DART AEROSPACE LTD	Work Order:	99459
Description: Crosstube Assembly	Part Number:	D206-667-243
Inspection Dwg: D206-667-243 Rev: C		Page 1 of 2

DRAWING NO. D206-667-243	TITLE CROSSTUBE ASS'Y (206L HIGH AFT)	REV. C	DART AEROSPACE LTD ENGINEERING ORDER		D.E.O. NO. D206-667-243-C-1	SHEET NO. SHEET 1 OF 1	SCALE NTS
DRAWN <i>q</i>	CHECKED <i>ASS</i>	MFG. APPR. <i>RB</i>	APPROVED <i>MP</i>	DE APPR. <i>#</i>			
DATE 11.07.15	DATE 11.07.20	DATE 11.07.21	DATE 11/07/21	DATE 11.07.21

PURPOSE:

REPLACE MAGNOBOND WITH PROSEAL.

DESIGN	9	DART AEROSPACE LTD
DRAWN	RF	HAWKESBURY, ONTARIO, CANADA
CHECKED	RF	DRAWING NO. D206-667-243
MFG. APPR.	RF	REV. C SHEET 3 OF 4
APPROVED	RF	TITLE CROSS TUBE ASSY (206L HIGH AFT)
DE APPR.	RF	SCALE NTS
DATE	08.11.06	COPYRIGHT © 2000 BY DART AEROSPACE LTD

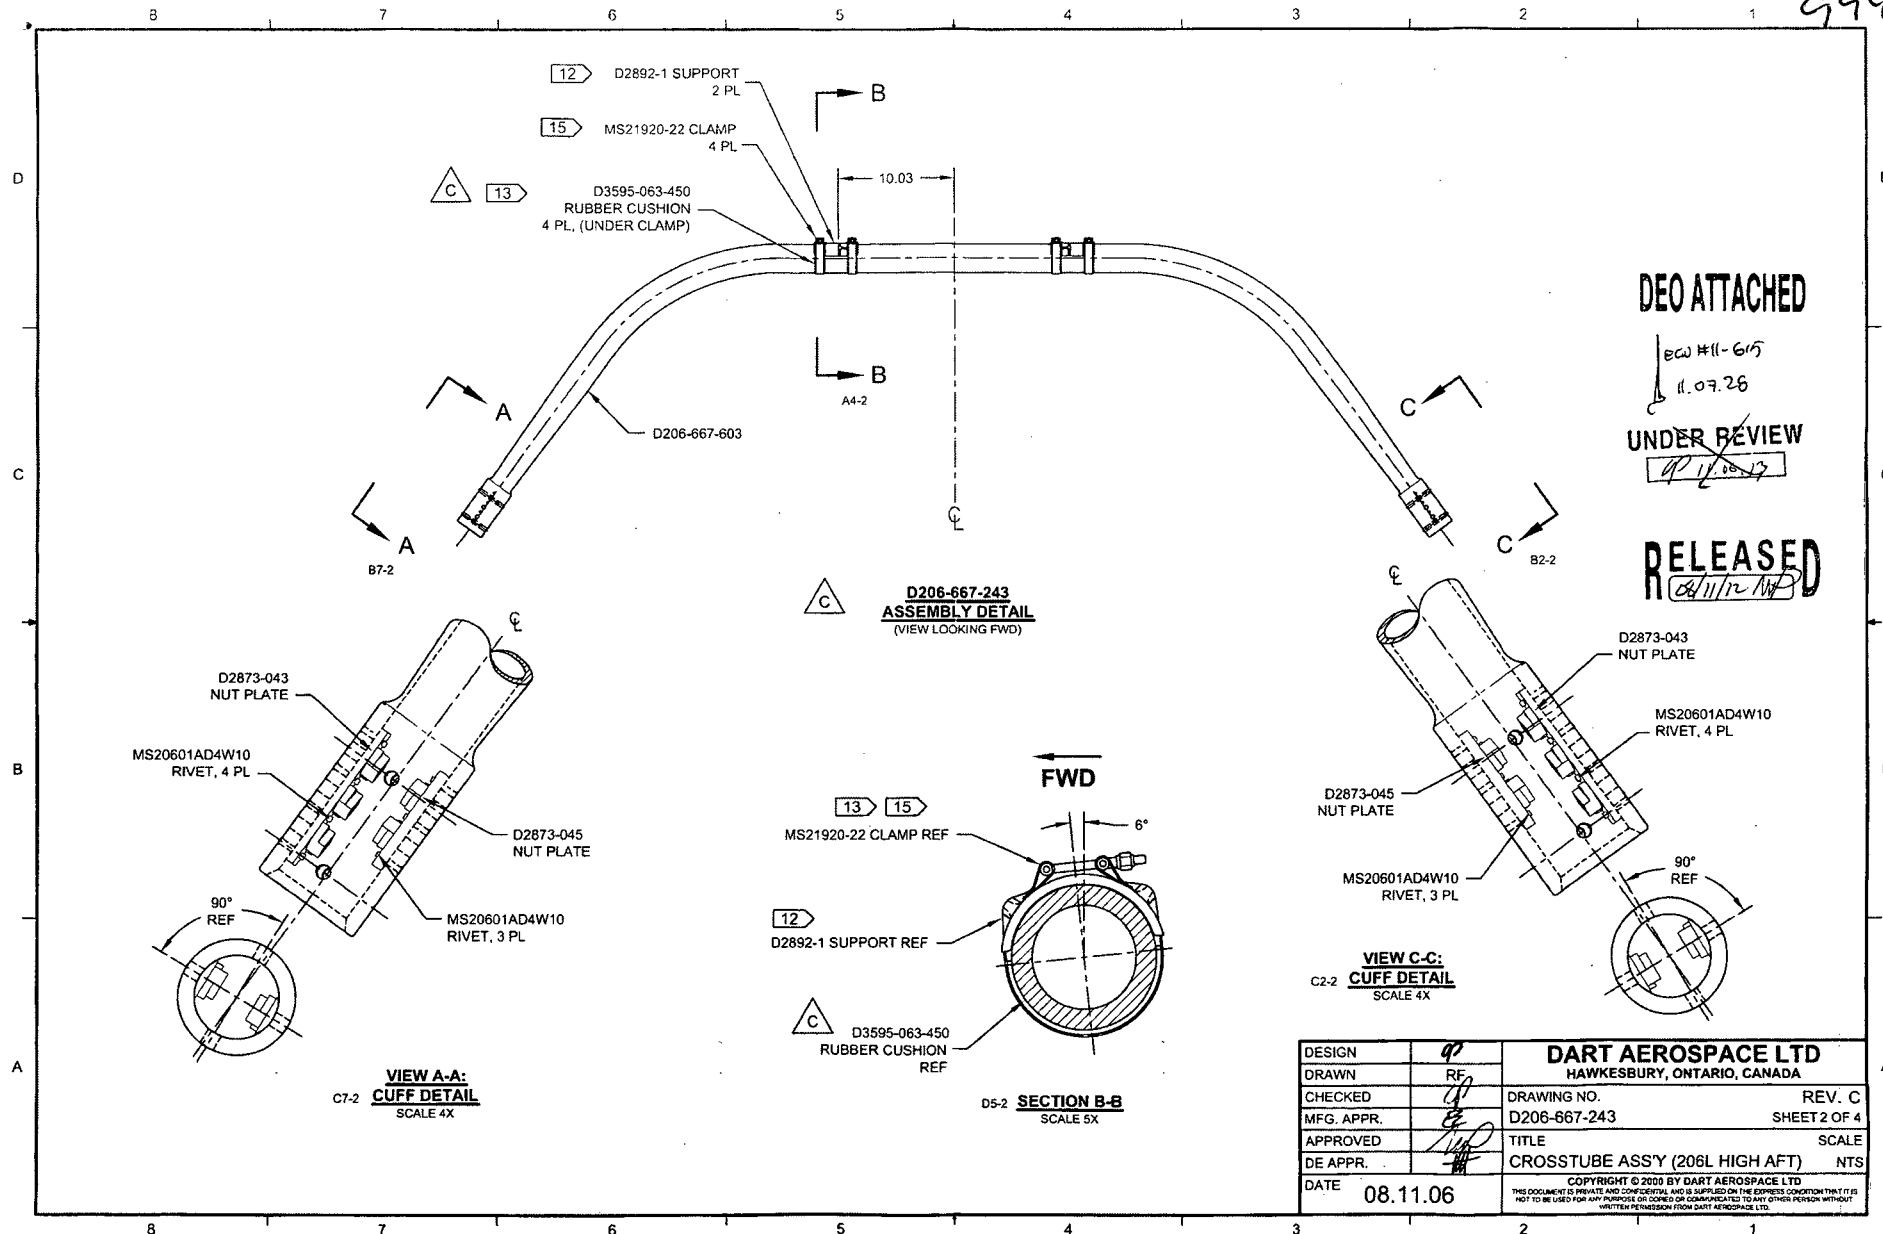
NOTE 12 & 15, SHEET 1 IS AMENDED AS FOLLOWS:

Item	Qty -243	Part Number	Description
9	A/R	PROSEAL 890 B-2	SEALANT, AMS-S-8802 CLASS B-2

- 12) TO INSTALL D2892-1 SUPPORT: ABRABE MATING SURFACE OF SUPPORT AND CROSSTUBE WITH 180-GRIT SANDPAPER AND REMOVE RESIDUE WITH MEK (OR EQUIVALENT). APPLY A 0.04" TO 0.07" THICK LAYER OF PROSEAL 890 CLASS B-2 (OR AMS-S-8802 CLASS B-2) SEALANT TO MATING SURFACE OF SUPPORT.
- 15) TORQUE CLAMPS 80 TO 100 IN-LB. ENSURE AT LEAST 1.5 THREADS SHOWING IN SAFETY AND THAT NUT HAS NOT BOTTOMED-OUT AFTER TORQUING. **PRIOR TO PACKAGING, RE-CHECK TORQUE ON CLAMPS AFTER PROSEAL 890 SEALANT HAS CURED FOR 72 HOURS.**
